DATE: March 22, 2010; updated April 13, 2002
TO: Stephanie Brown, Seattle Department of Transportation
FROM: David Graves, AICP, Senior Planner
SUBJECT: SR 520 Supplemental Draft Environmental Impact Statement

Attached are comments of Seattle Parks and Recreation on the SR 520, I-5 to Medina Bridge Replacement and HOV Project Supplemental Draft Environmental Impact Statement (SDEIS). The purpose of this memo is to highlight selected policy issues of substantial significance that should be brought forth in the City's response to the SDEIS.

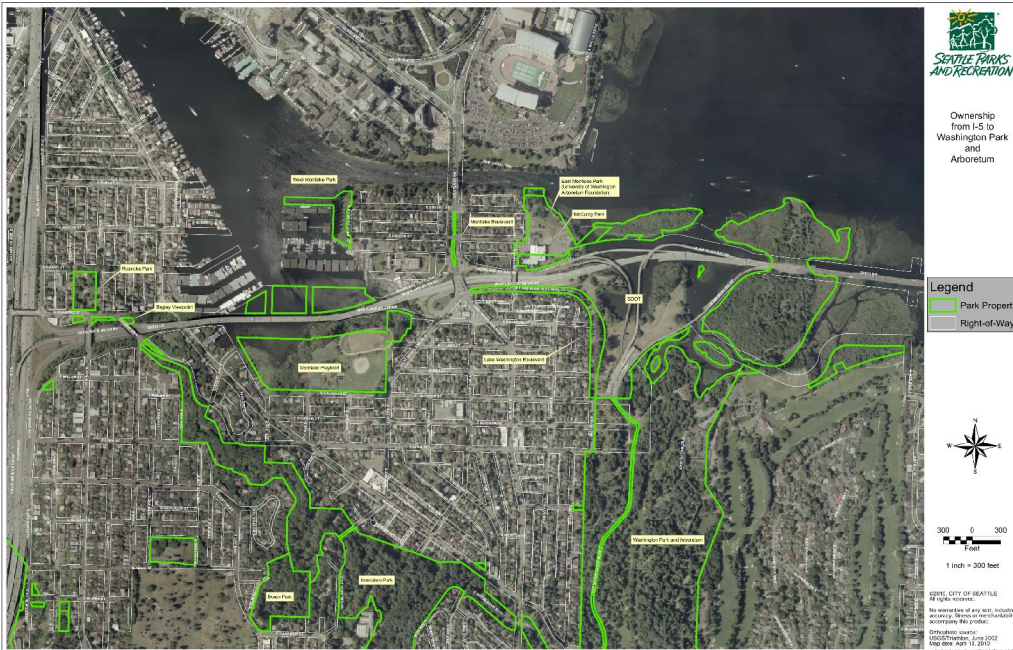
If implemented, proposed upgrades to State Route 520 will have significant impacts to a number of Seattle parks over a span of years, and a base set of impacts for the life of the freeway corridor. There will be impacts to park resources protected under Section 4(f) of the Federal Highway Administration legislation associated with the SR 520 project. City of Seattle park resources under the jurisdiction of the Superintendent of Seattle Parks & Recreation that will be impacted by the SR 520 project include Roanoke Park, Bagley Viewpoint, West Montlake Park, Montlake Playfield and the associated submerged lands, Lake Washington Boulevard, East Montlake and McCurdy Parks and the Washington Park Arboretum. (see attached map) As such, appropriate mitigation of the project impacts is warranted and necessary.
